Reliability Analysis Update

Transmission Expansion Advisory Committee
May 6, 2025

Scope Change & Cost Updates Baseline Reliability Projects

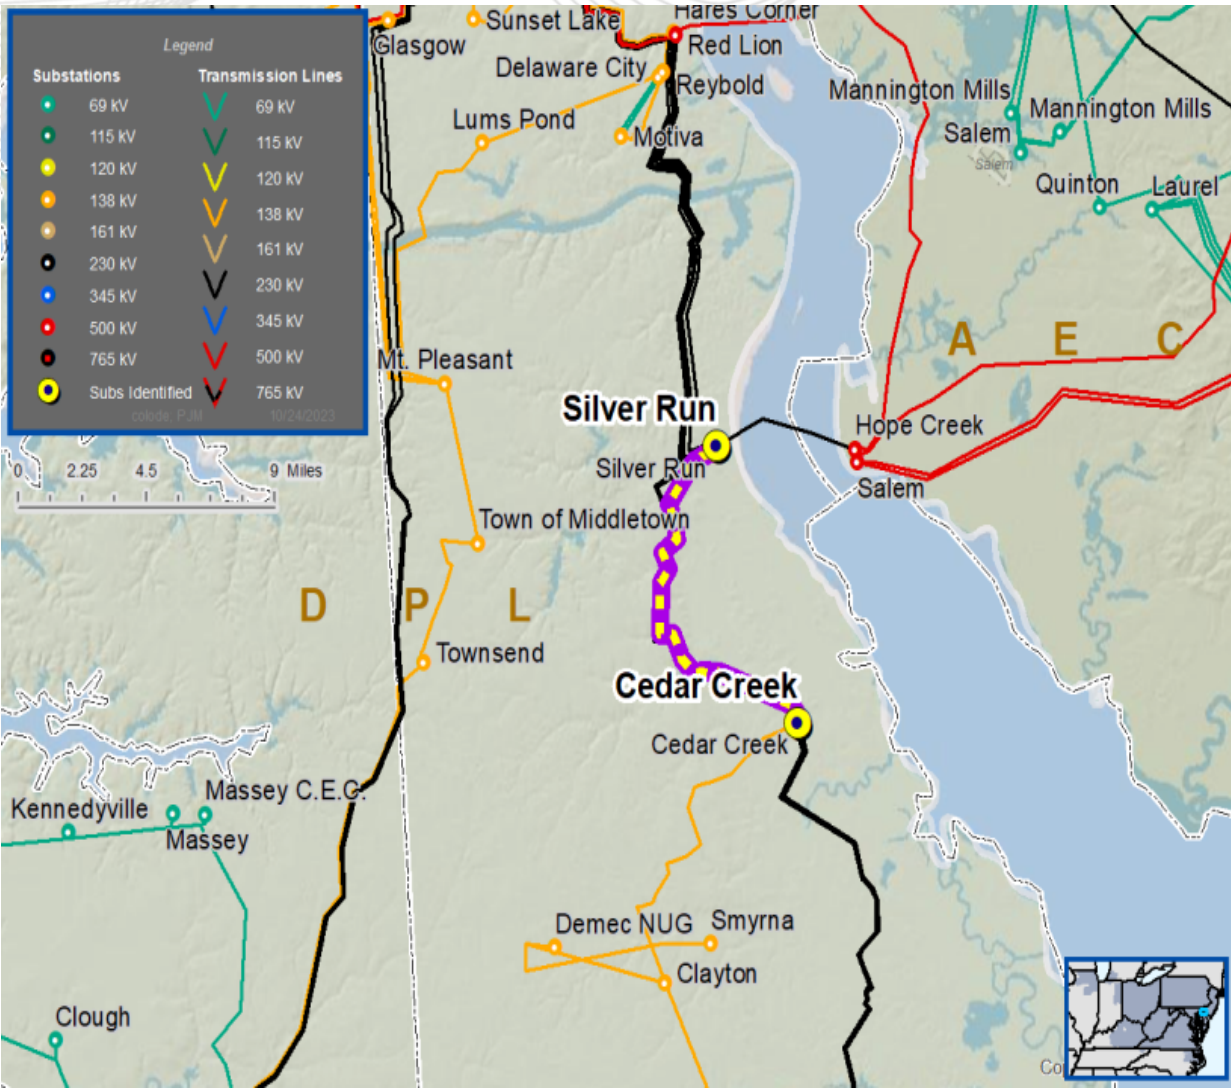
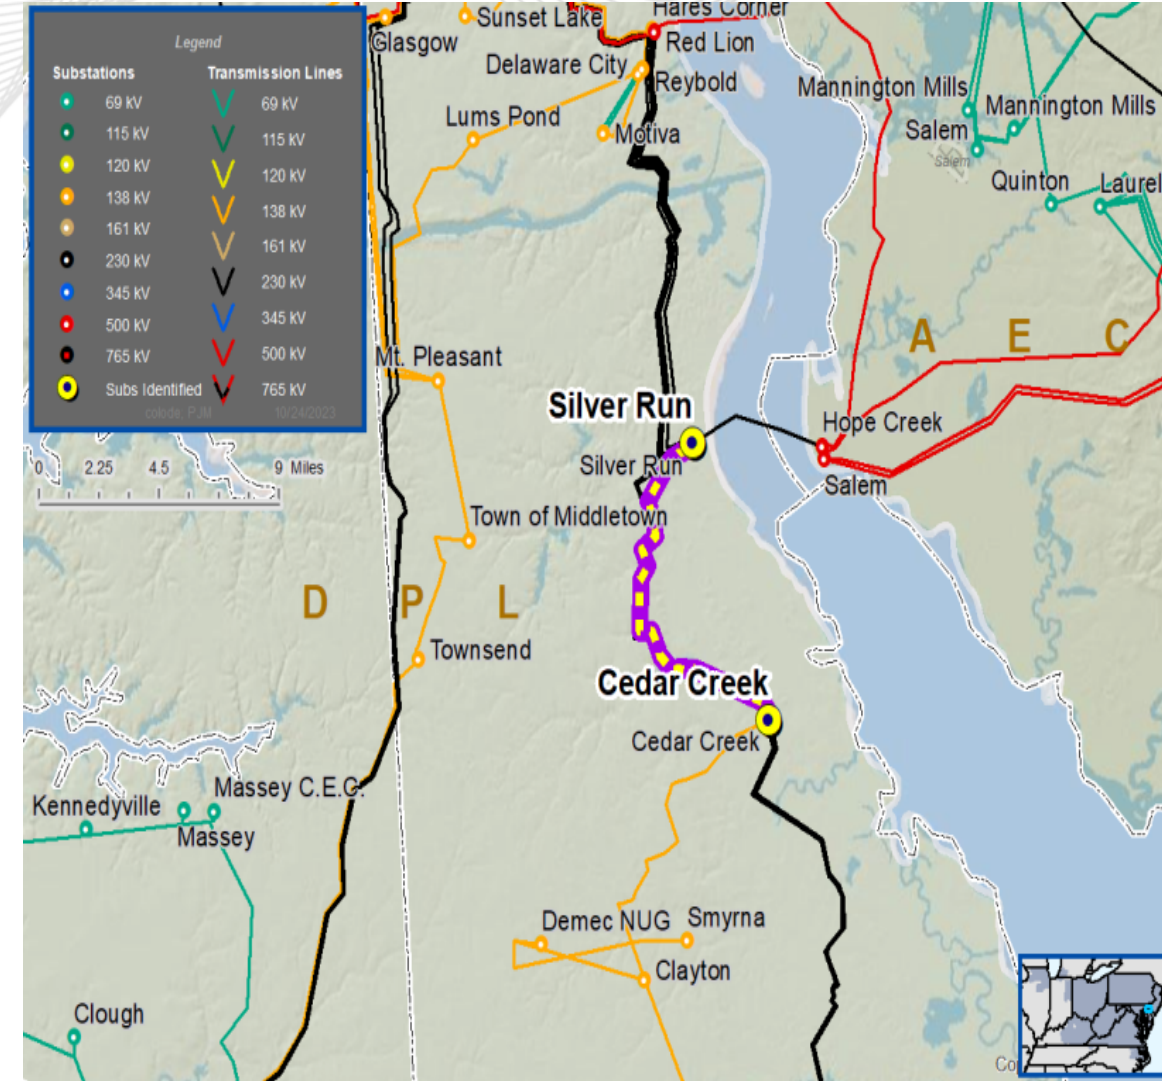
- PJM is correcting the designated entity for the B3793.3 upgrade. The project scope involves a tie line between DPL and LS Power, but the B3793.3 substation equipment upgrade at Silver Run was incorrectly assigned to DPL. B3793.3 will be canceled and replaced with B3793.4, which will be assigned to LS Power resulting in no change to the cost of this project.

- Reconductor Silver Run - Cedar Creek 230kV line. Reconductor 8.8 miles of 230 kV Circuit with 1594-T11/ACCR “Lapwing” conductor and replace all insulators with high temp hardware. **(B3793.1)**
- **Cedar Creek**– Replace three (3) standalone CTs, disconnect switch, stranded bus, and rigid bus to achieve higher rating. **B3793.2)**
- ~~**Silver Run**– Replace three(3) 1-1590 ACSR Jumpers and one(1) air disconnect switch. **B3793.3) Estimated Cost: \$0.58M**~~
- **Silver Run** - Replace three(3) 1-1590 ACSR Jumpers and one(1) air disconnect switch. **B3793.4) Estimated Cost: \$0.58M**

Scope Change & Cost Update for Baseline Project b3737.50

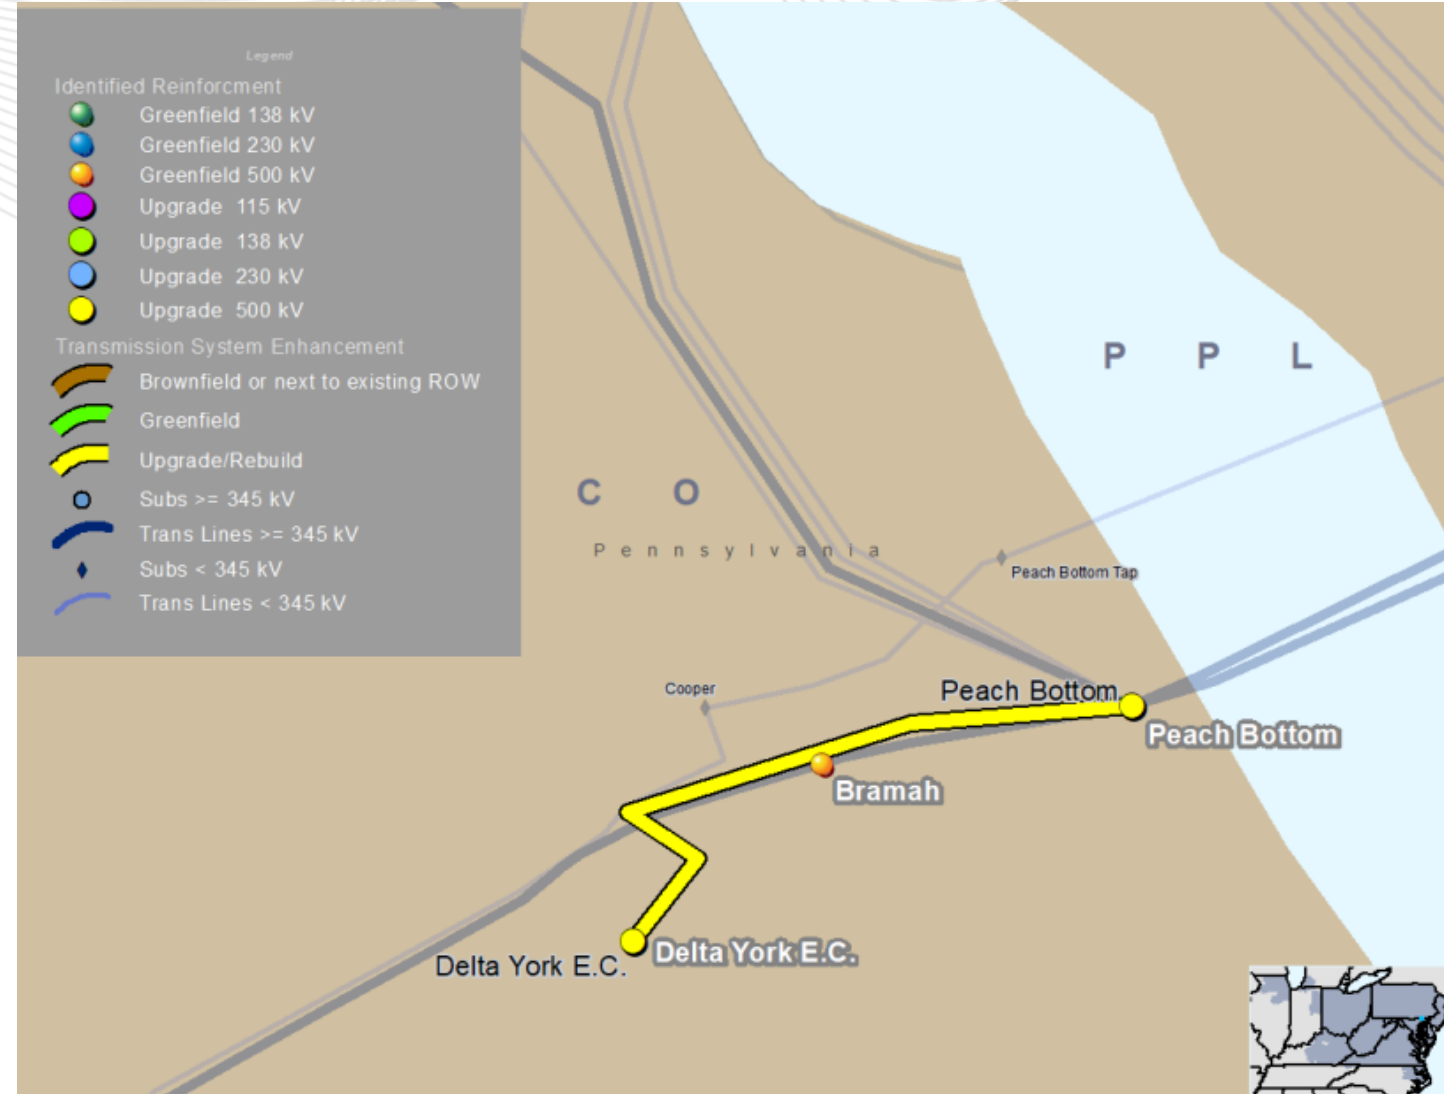
Bring the Peach Bottom-Delta York 500 ‘5034’ kV line “in and out” of Bramah substation by partially demolishing the 5034 line to construct a new Peach Bottom – Bramah – Delta York 500 kV line, with 0.87 miles of cut-in and cut-out lines.

The Project and cost was originally proposed by Transource as part of NJBPU SAA 1.0. The 5034 line is in fact, currently owned by Calpine. Calpine and PECO have reached an agreement that will allow PECO to effectuate the cut-in of the 5034 line into the new Bramah (North Delta) 500 kV substation. PECO will assume Transmission Owner responsibility for the 5034 line, subject to FERC approval. PJM’s recommendation of this scope change is conditioned on FERC’s approval of the pending transaction. The revised project and cost reflects PECO’s estimation of the new scope and cost to cut-in the line to Bramah substation.

Estimated Cost ~~\$1.56M~~ **\$12M**
